Topway Industries Limited

27 September 2023

Observations

Lack of lateral stability system

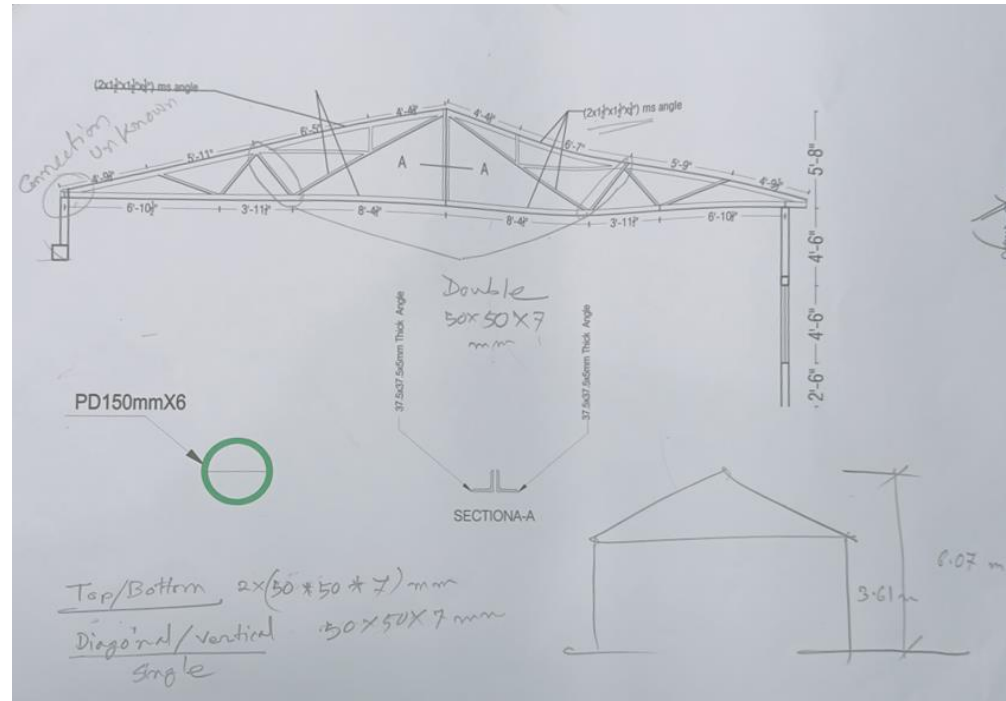
Load transfer media is not provided along long direction for this shed. Therefore, lateral stability system of the shed is apparently incomplete. The building engineer is required to check the stability system of the existing structure.

Lateral stability system required review

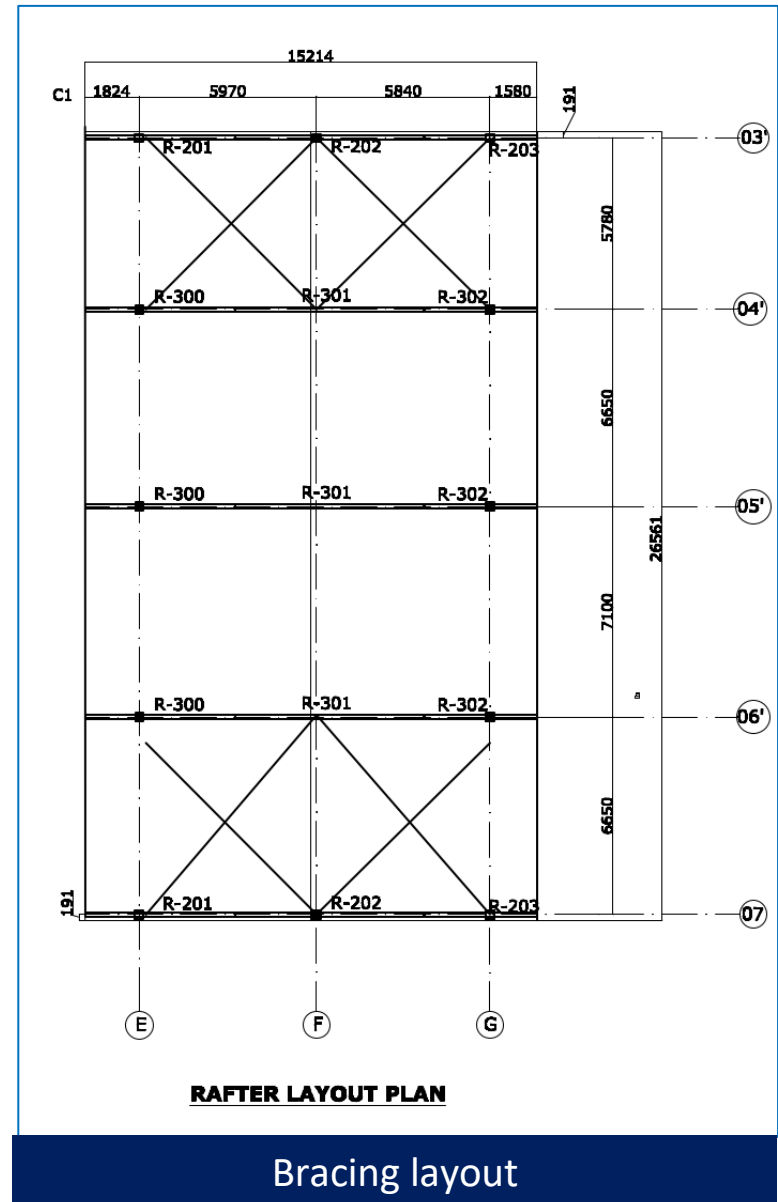
No compression strut was found along the long direction. Also, bracings were found missing as per drawings. So lateral stability in the long direction is incomplete. The building engineer is required to check the stability system of the existing structure.

Discrepancies in as-built drawing

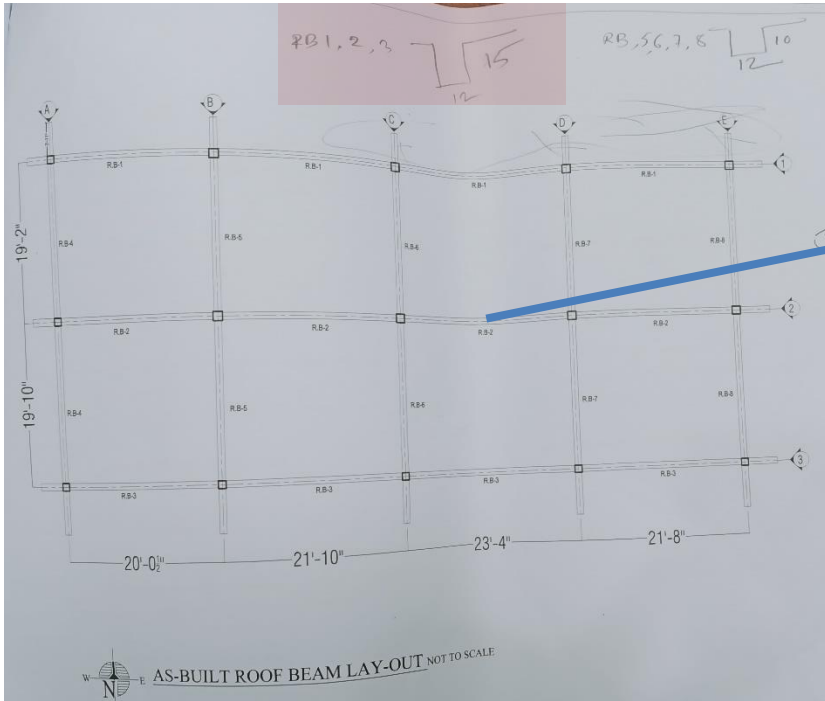
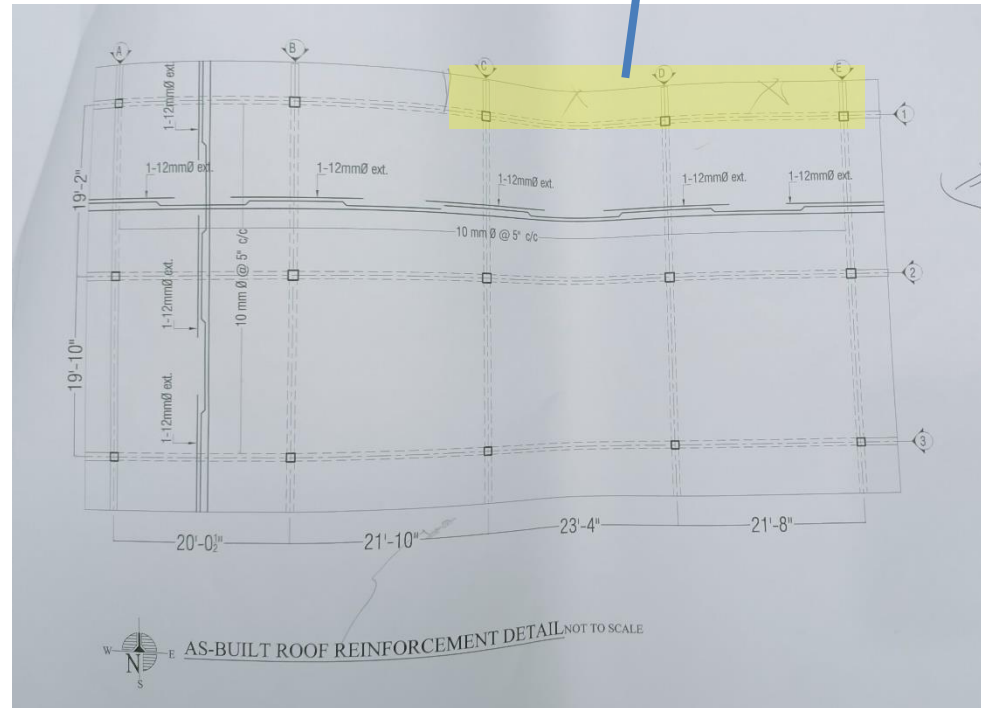
Longitudinal beam down stand was found 375 mm instead of 250 mm. Also slab and cantilever beam layout did not match fully with as built condition. Building engineer is required to survey the structure and prepare accurate as-built drawings.

Bolt missing

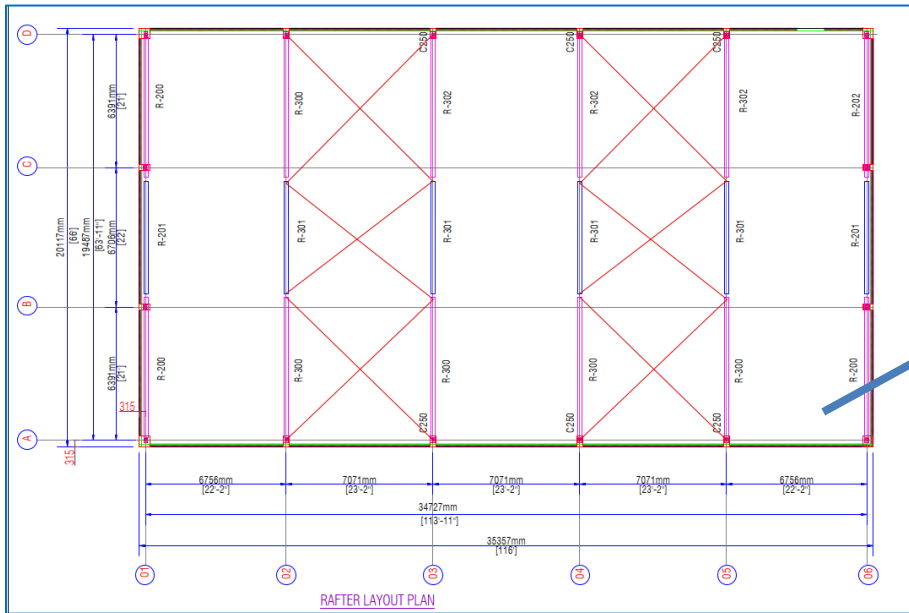
Bolt missing in rafter-column joint. Building engineer is required to install the missing bolts where necessary.

Wastage Shed

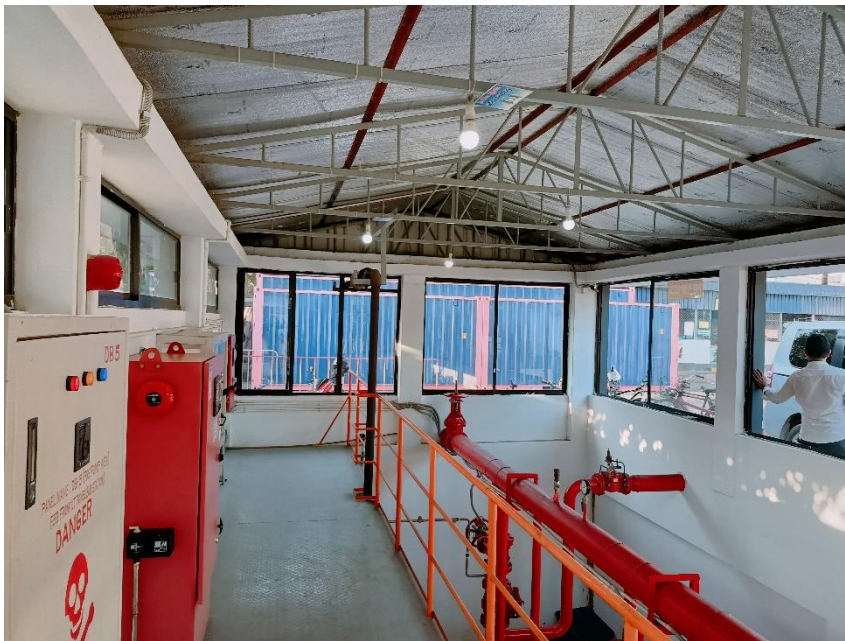
Full set of as-built structural drawings were not found for Fire hydrant pump room, Wastage Shed. Sectional details (truss & Rafter) were not found. Moreover, grid dimension and steel column size not match with as-built condition. The building engineer is required to survey the whole structure and prepare a full set of as-built drawings in compliance with section 1.9.1.2, part 6 of BNBC.

Apparently non-engineered connection/Shed

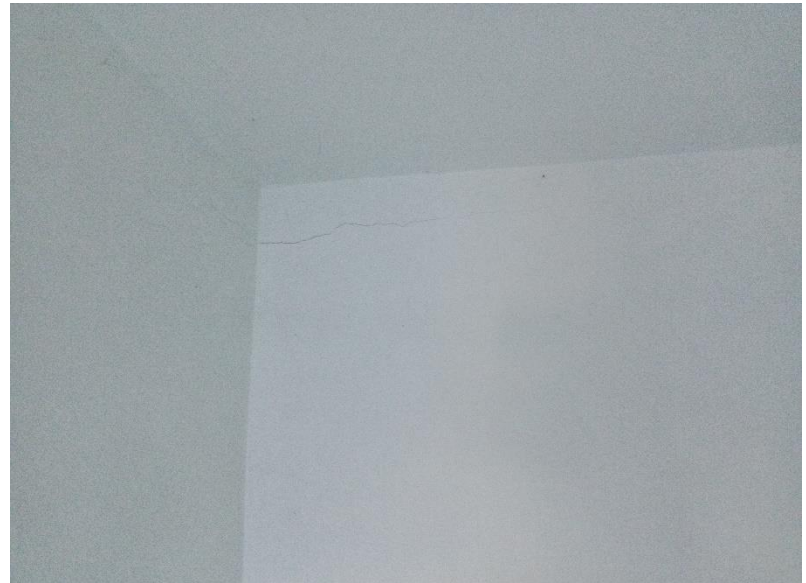
Apparently inadequate connections were observed at the lightweight roof of the single storied Sheds. The building engineer to check the connection adequacy of the lightweight roof against the uplift pressure of wind and suggest suitable remedial method. Otherwise replace with an engineered shed.
